SUBJECT: Beaver Valley Power Station - Unit No. 2
Docket No. 50-412
Response to Draft SER Open Item Nos. 175 and 176

Draft SER Open Item No. 175 (Section 2.5.4.3.3) - Measured, Estimated, and Allowable Settlement Data:

Draft SER Open Item No. 176 (Section 2.5.4.3.3) - Differential Settlements:

FIGURE 2.5.4-20
 PREDICTED TOTAL STATIC
 SETTLEMENT
 BEAVER VALLEY POWER STATION-UNIT 2
 FINAL SAFETY ANALYSIS REPORT

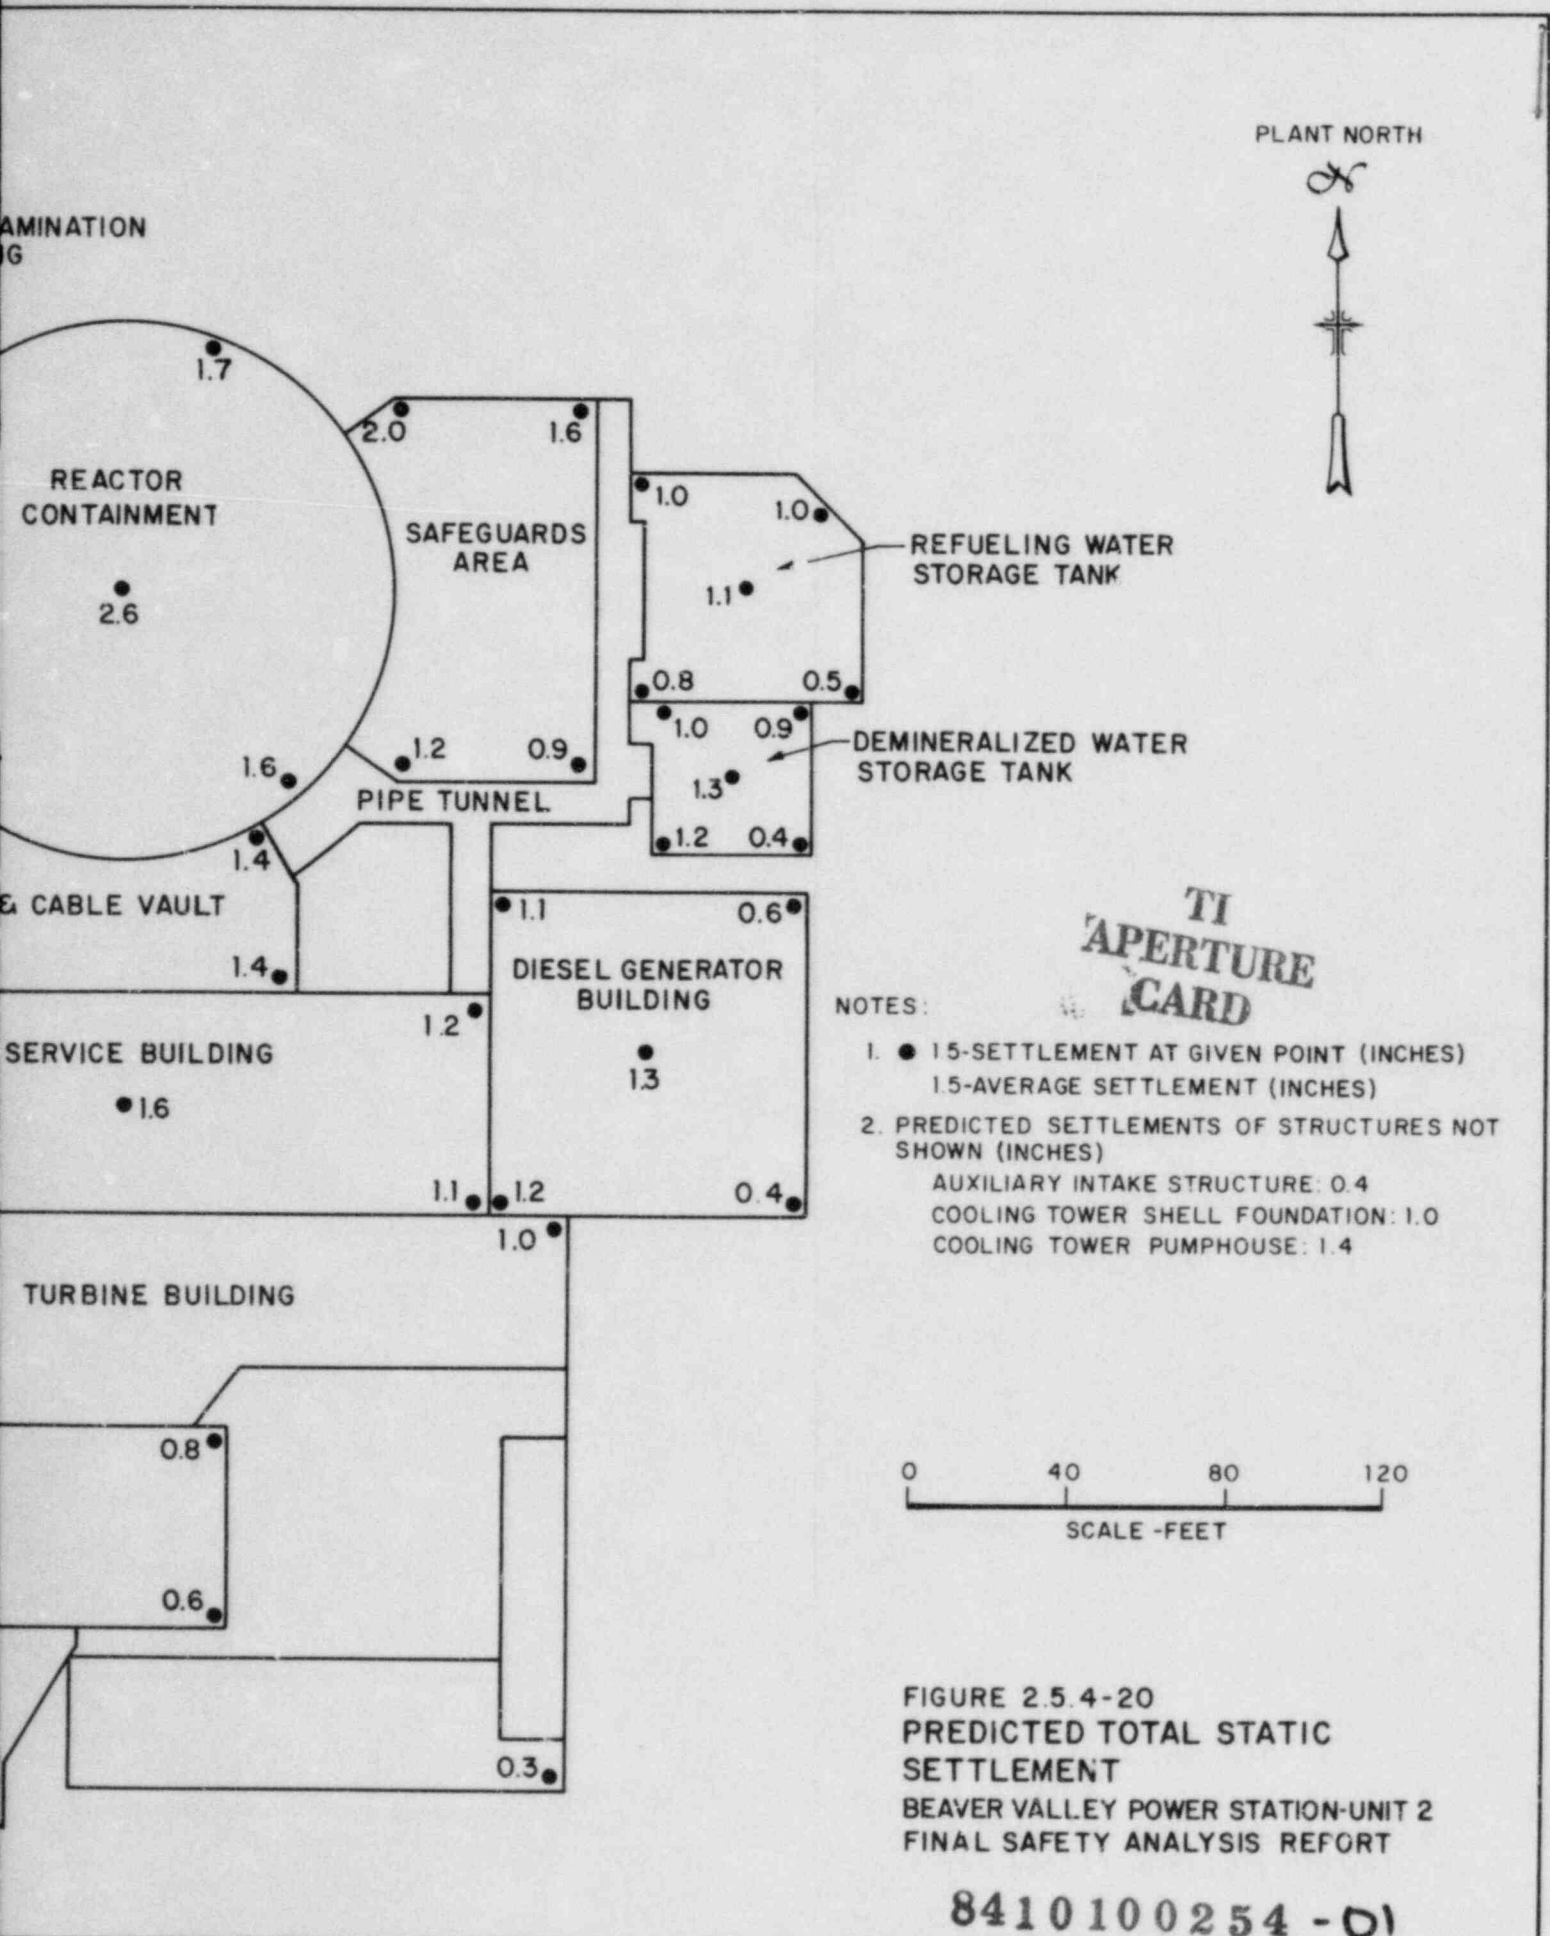
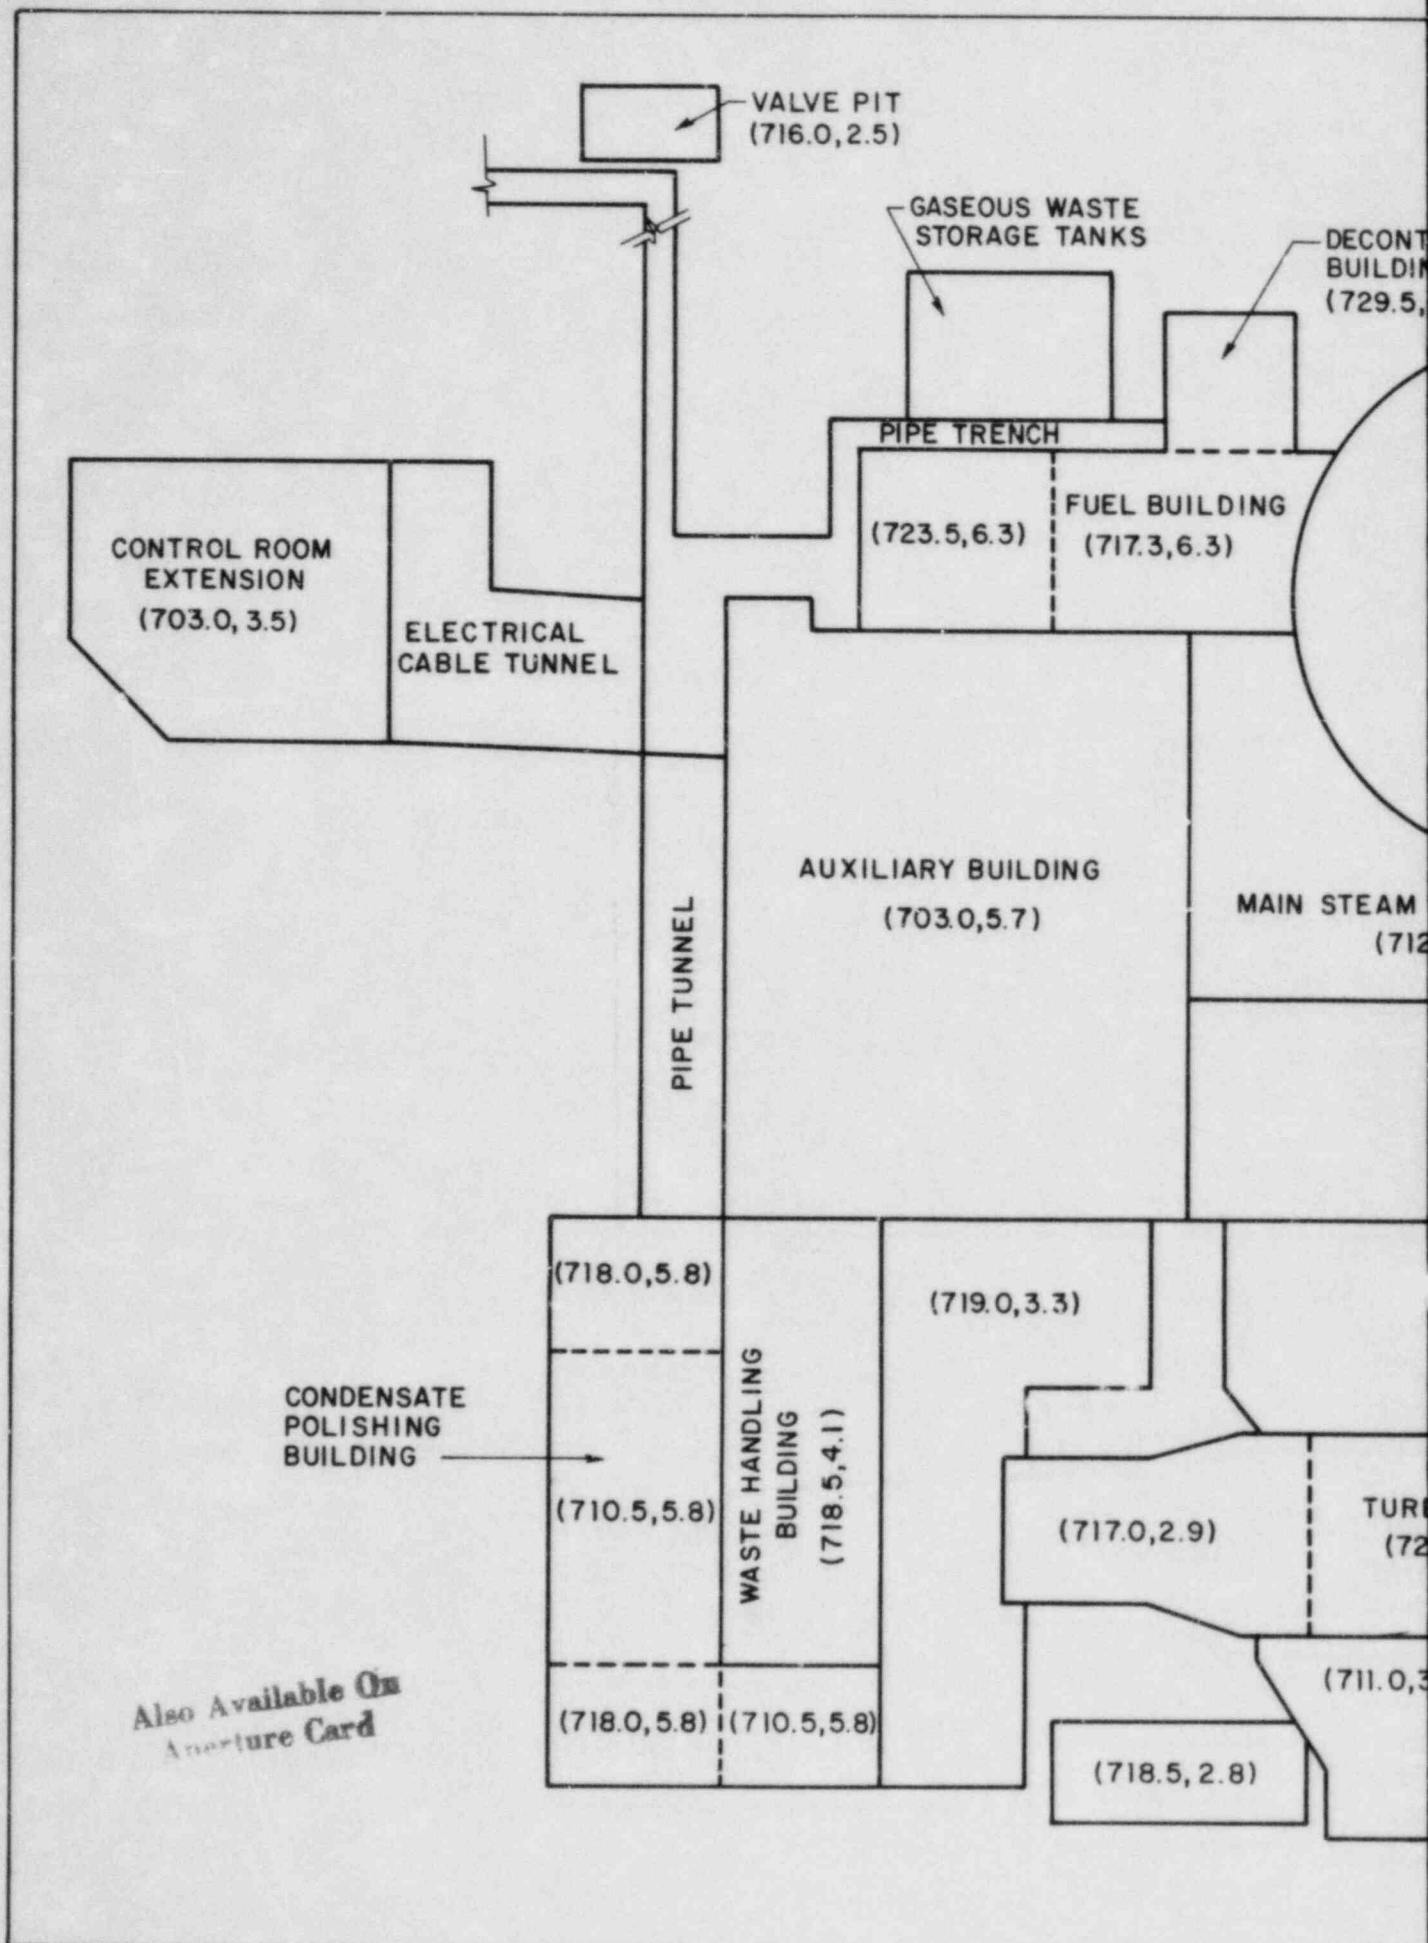
Based on the settlement data given in the FSAR Figures 2.5.4-20, and 2.5.4-46, Table 2.5-2 gives a comparison of the estimated and measured total settlement at the corners of a few Category I structures. This table also gives the percentage of structural loading of these structures as of January 10, 1984, provided by the applicant during the geotechnical audit by the staff in January 1984. The applicant has been requested to docket this data, including a comparison of up-to-date measured settlements with predicted values, in a tabular form in the forthcoming amendment of the FSAR. The applicant needs to provide the total loading including the equipment loading, etc. in addition to civil, steel, and concrete loading.

1. Allowable total settlement and tilt of safety related structures.

FSAR Figure 2.5.4-20, Amendment 8 (attached), has been revised to indicate a change to the predicted settlement of the valve pit as a result of an increase in the design load shown in FSAR Table 2.5.4-4, Amendment 6. FSAR Figure 2.5.4-41, Amendment 8 (attached), has been revised to agree with the loads shown in Table 2.5.4-4.

Allowable total static settlements of the individual BVPS-2 structures have not been determined. However, a prediction of the static settlement of each structure has been made (FSAR Figure 2.5.4-20) to provide an indication of the behavior of plant structures. An extensive settlement monitoring program has been instituted at BVPS-2 to verify the validity of the predictions. The settlement monitoring data will ultimately be used to reassess the predicted settlements of each structure taking into consideration the trends shown by the measured data at each settlement monitoring point. The individual plant structures are not specifically designed for differential settlement or tilt of the foundation. However, observed settlements are periodically reviewed so that any unusual movements can be evaluated on a case-by-case basis.
